### **BOARD OF ZONING ADJUSTMENT STAFF REPORT**

### **Date: March 7, 2016**

CASE NUMBER	6030
APPLICANT NAME	Goodwyn Mills & Cawood, Inc. (Tracy Bassett, Agent)
<b>LOCATION</b>	2 North Royal Street (Northeast corner of North Royal Street and Dauphin Street)
VARIANCE REQUEST	<b>SIGN:</b> Sign Variance to allow two individual storefront signs, one wall plaque, and three traffic directional signs for a business in a T-6 Sub-District within the Downtown Development District.
<u>ZONING ORDINANCE</u> <u>REQUIREMENT</u>	<b>SIGN:</b> The Zoning Ordinance allows one individual storefront sign, no wall plaques, and does not address traffic directional signs for a business in a T-6 Sub-District within the Downtown Development District.
ZONING	Form Based Code T-6
AREA OF PROPERTY	0.24± Acre
ENGINEERING COMMENTS	No comments
TRAFFIC ENGINEERING COMMENTS	No comments.
<u>CITY COUNCIL</u> <u>DISTRICT</u>	District 2

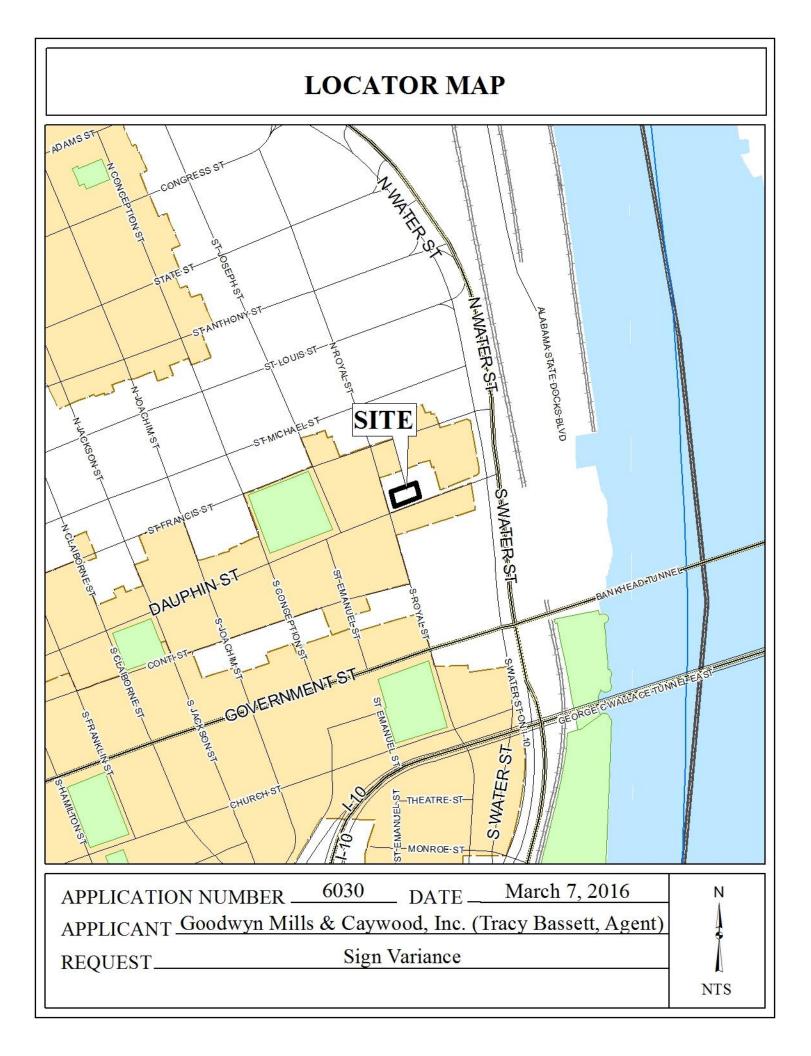
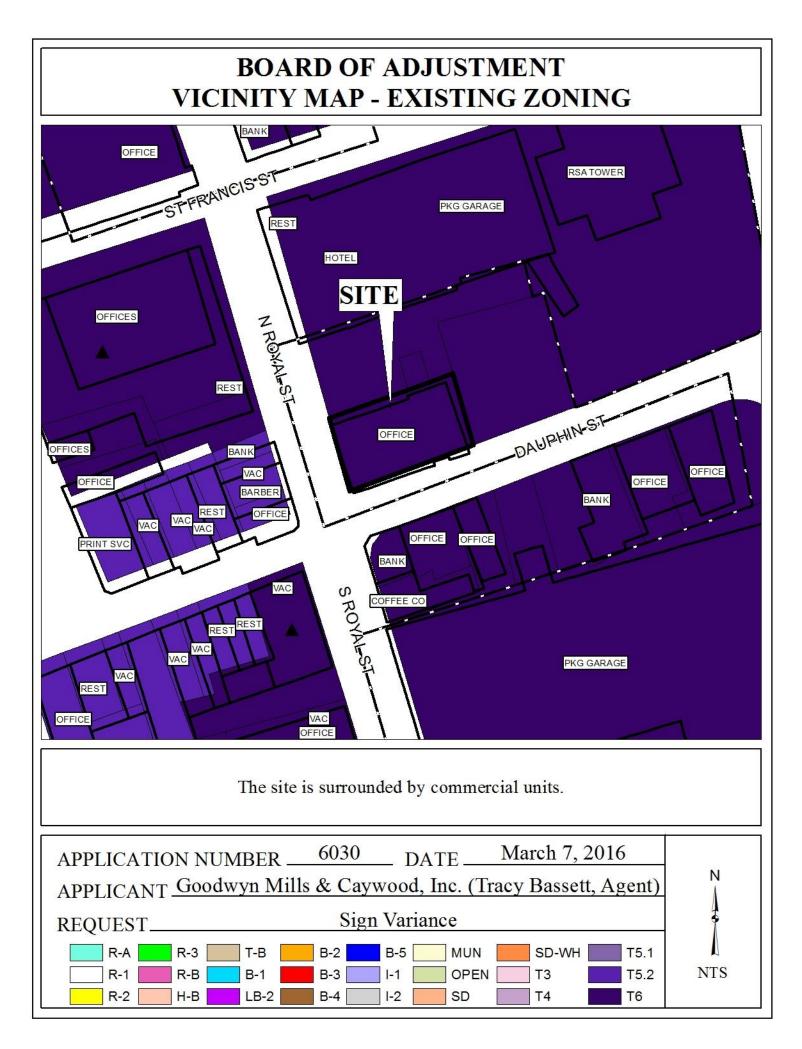
The subject site is located at a street corner and the DDD signage regulations allow one diagonal corner sign per building at street corners. However, the subject building has balconies along both street frontages which would make such a sign unattractive, and this type of sign would encroach into walking space along the balcony level. And due to the balcony and roof overhangs, this type of sign would be somewhat obscured from visibility. Due to the street corner location, the applicant proposes one individual storefront sign to be placed on the balcony fascia at the corner facing each street. Each sign would be 1'-10" high by 4'-9-1/2" wide, or 8.78 square feet each. As the DDD signage regulations allow individual storefront signs to be 3' high by the length of the building (74'-4" along the Royal Street front, and 131' along the Dauphin Street front), the proposed signs would only be a fraction of what would normally be allowed along each frontage.

The proposed wall plaque would be a re-use of an existing sign at another location of the Servis 1<sup>st</sup> Bank and is proposed to be close to the main pedestrian entrance at the middle of the building. This would be the only identity signage visible to pedestrians within that street block. Wall plaques are not allowed in a T-6 district, but are allowed up to 2 square feet in T-3 and T-4 districts within the DDD. The proposed plaque is 2.5 square feet, just slightly over the allowable size in other districts. The plaque would not be much different from a painted wall sign which is allowed within T-6 districts with no size restrictions. Therefore, the re-use of an existing sign well within the allowable size area of a painted wall sign would not seem to be against the intent of the DDD Signage Standards.

Also proposed by the applicant are three traffic directional signs at the banking drive-thru street entrance (two OPEN/CLOSED signs and one DRIVE-THRU sign). Although classified as a building sign by the applicant, traffic directional signs are not even addressed in the DDD Signage Standards and the proposed signs must be included in the Variance request. The DRIVE-THRU sign would be 3 square feet, and the OPEN/CLOSED signs would each be 1 square foot. Such signs are allowed without permits up to 20 square feet in commercial districts outside the DDD and up to 40 square feet at hospitals. Due to the fact that such signage is necessary to identify the vehicular entrance to the banking drive-thru facility and to designate the status of the two traffic lanes, the allowance of such signage would actually be a matter of practicality and safety.

The applicant has illustrated a hardship to justify the request for two individual storefront signs due to the fact that the building is a corner site and the architectural features of the building would make a diagonal corner sign impractical. No genuine hardship has been illustrated for the request of the plaque sign as opposed to an allowed painted wall sign, but the proposed re-use would not seem out of character for the site. And the proposed traffic directional signs should be considered a necessity for the banking drive-thru facility. Therefore, the Board should consider all requested signage for approval, subject to conditions.

Therefore, this application is recommended for approval, subject to the following conditions:

- 1) obtaining of sign permits for the two individual storefront signs and the wall plaque;
- 2) obtaining of electrical permits for the illuminated traffic directional signs; and
- 3) full compliance with all other municipal codes and ordinances.
